DEVELOPMENT REVIEW BOARD MEETING

2. **Resolution No. 443. iONNA Electric Vehicle Charging Station.** The applicant is requesting approval of a Stage 1 Preliminary Plan, Stage 2 Final Plan, Site Design Review, and Class 3 Sign Permit for an electric vehicle (EV) charging station with 16 EV charging stalls and an amenities building housing restrooms and vending machines.

**DEVELOPMENT REVIEW BOARD
RESOLUTION NO. 443**

Exhibit A1
Staff Report
Wilsonville Planning Division
iONNA Electric Vehicle Charging Infrastructure

Subsection 4.400 (.02) D. and Subsection 4.421 (.03)

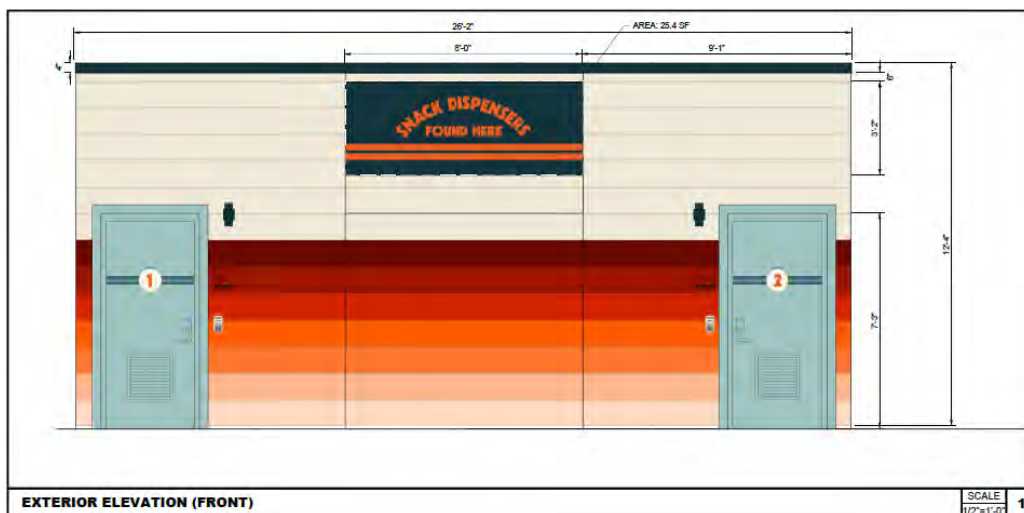
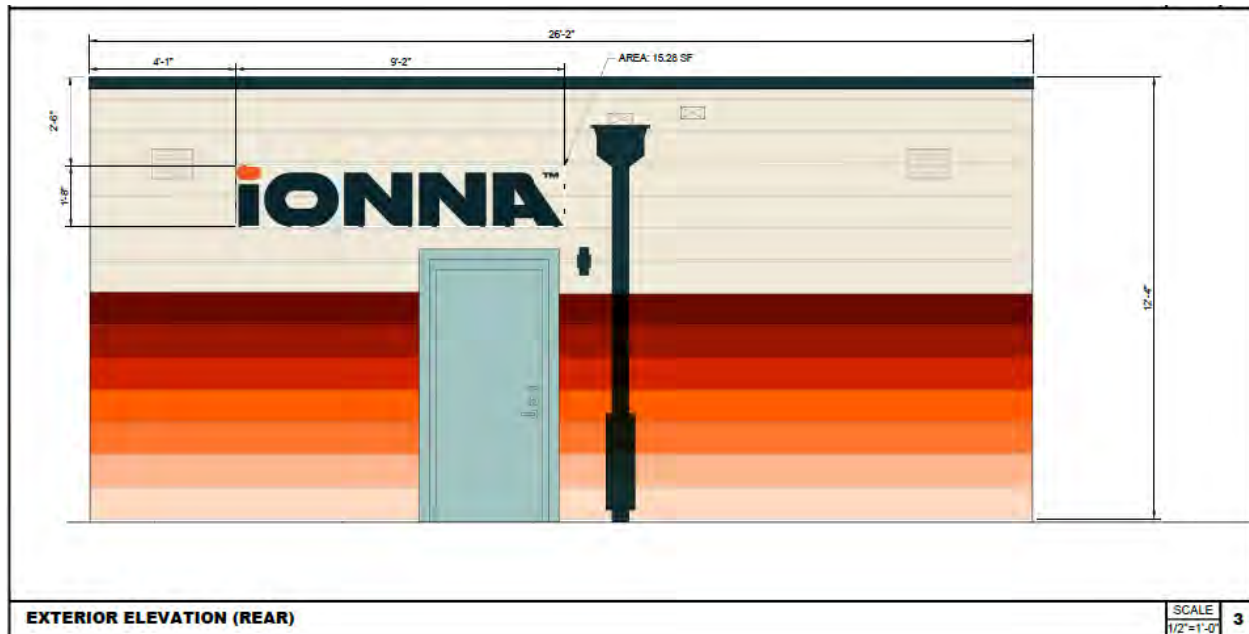
- C8. The applicant used appropriate professional services to design the exterior of the building. The building will be built using Hardie plank siding and will use color to create visual interest.
